Technical Service Bulletin: TSB180042	Released Date: 07-May-2018
Heat Exchanger Mounting Bracket Installation

Heat Exchanger Mounting Bracket Installation

Figure 1, Heat Exchanger Mounting Bracket Gap

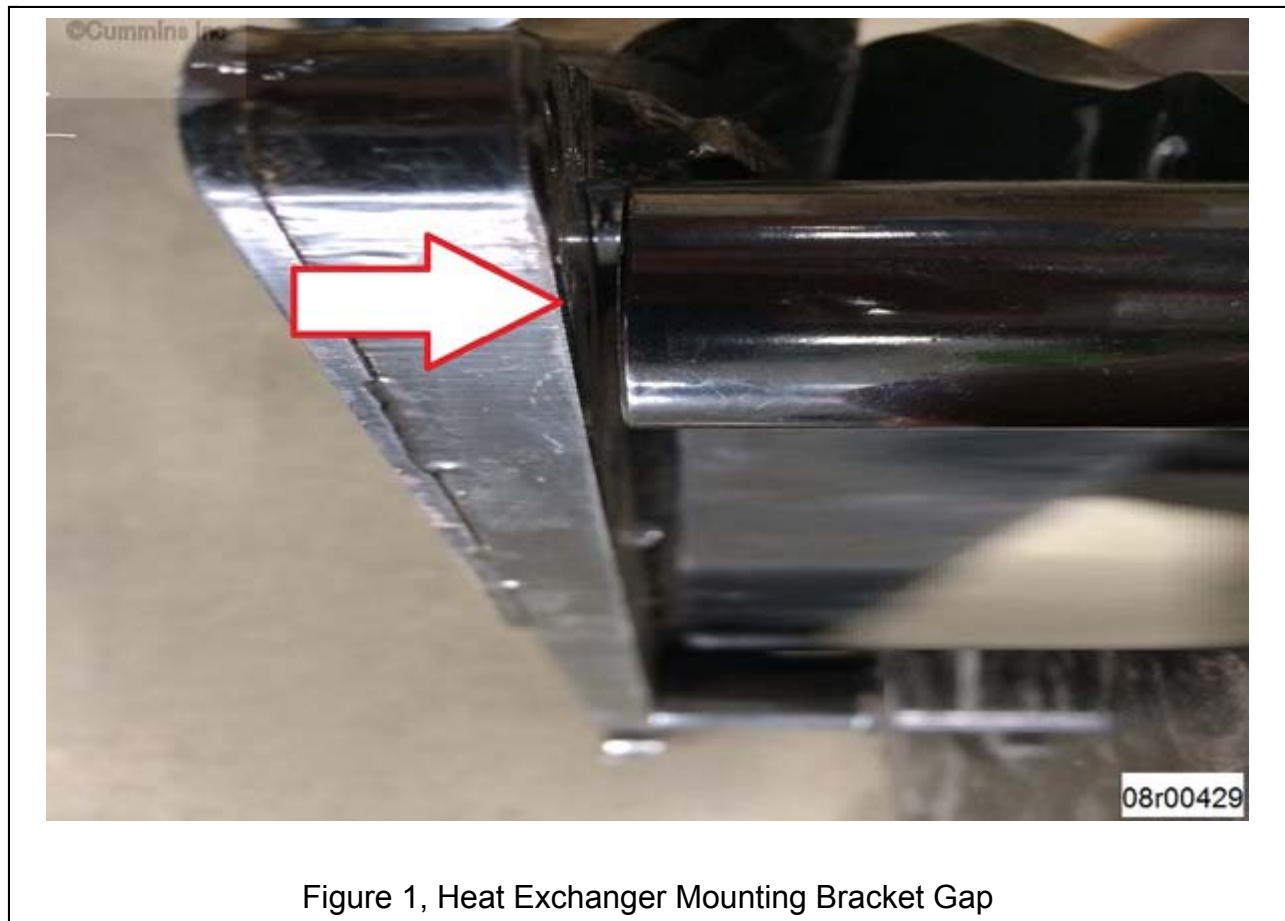
Heat exchanger mounting bracket, Part Number 5289017, has gaps when mounted to engine.

Incorrect initial assembly procedure.

Inspect for gaps at heat exchanger mounting bracket mounting points as indicated by Figure 1.

If gaps are identified loosen all mounting capscrews and follow the torque procedure below:

1. Torque bottom two mounting screws to 43 n•m [32 ft-lb], working from front to rear of engine.
2. Torque top mounting screws to 43 n•m [32 ft-lb], working from front to rear of engine.
